Access Compliance Report Public Rights-of-Way (Curb Ramps)

Main Street: LA_LOMA_DR Cross Street: NEWPORT_AVE Location: N

ADA ID: RPRK211008142529 Ramp Type: Type 1 - Perpendicular Diagonal Initial Pass/Fail: Fail Overall Compliance: No Severity Score: 20

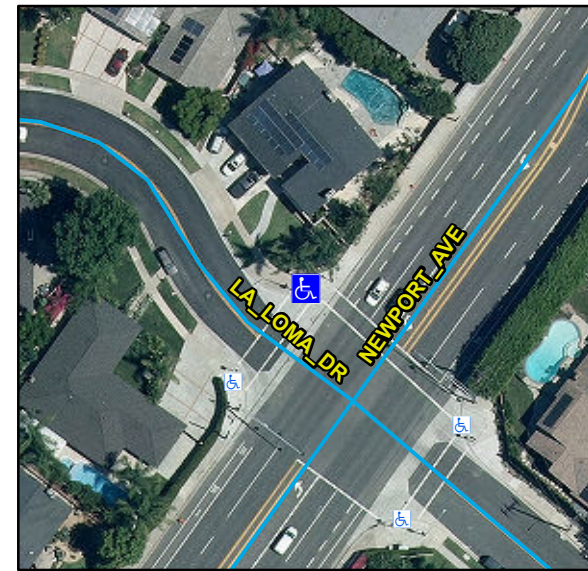
R304.2.2, R304.5.1, STD 1115

Compliance	Description	Data	Compliance	Description	Data
N/A	Ramp Length (in)	135	N/A	Flare Type LT	
No	Ramp Width (in)	47			N/A
No	Ramp Run Slope (%)	11.4	N/A	Flare Slope LT (%)	N/A
Yes	Ramp Cross Slope (%)	1.7	N/A	Flare Traversable LT	N/A
N/A	Landing Present	N/A	N/A	Flare Type RT	
N/A	Landing Length (in)	N/A			N/A
N/A	Landing Width (in)	N/A	N/A	Flare Slope RT (%)	N/A
N/A	Landing Run Slope (%)	N/A	N/A	Flare Traversable RT	N/A
N/A	Landing Cross Slope (%)	N/A	N/A	DWS Provided	N/A
N/A	Landing Movement Obstructed?	N/A	N/A	DWS Contrast	N/A
	Landing Movement Type	N/A	N/A	DWS Length (in)	N/A
N/A	Landing Shared	N/A	N/A	DWS Full Width	N/A
N/A	Clear Space	Yes	N/A	DWS Offset Left (in)	N/A
N/A	Clear Space To Crosswalk (in)	48	N/A	DWS Offset Right (in)	N/A
N/A	Marked Crosswalk 1	Yes	N/A	Marked Crosswalk 2	Yes
	Crossing 1 Direction	SW		Crossing 2 Direction	SE
	Marked Crosswalk 1 Width (in)	100		Marked Crosswalk 2 Width (in)	100

N/A	Ramp Inside Crosswalk 1	Yes	Yes	Ramp Inside Crosswalk 2	Yes
	Crossing 1 Slope (%)	8.8		Crossing 2 Slope (%)	7.4
	Crossing 1 Cross Slope (%)	4.3		Crossing 2 Cross Slope (%)	0.8
N/A	Gutter Ponding	N/A	No	Curb Slope	17.6
Yes	Gutter Lip Height (in)	0		Road Run Slope (%)	0.6
N/A	Gutter Run Slope (%)	N/A		Road Cross Slope (%)	1.2
N/A	Gutter Cross Slope (%)	N/A			
Yes	Overall Surface Condition: Acceptable		Yes	Perp Joint Present	Yes
	Cross Gutter Present?	No		Spandrel Present?	No
	Replace Cross Gutter?	N/A		Replace Spandrel?	N/A

Remove & Replace Curb Ramp With Two New Directional Ramps or Equivalent.
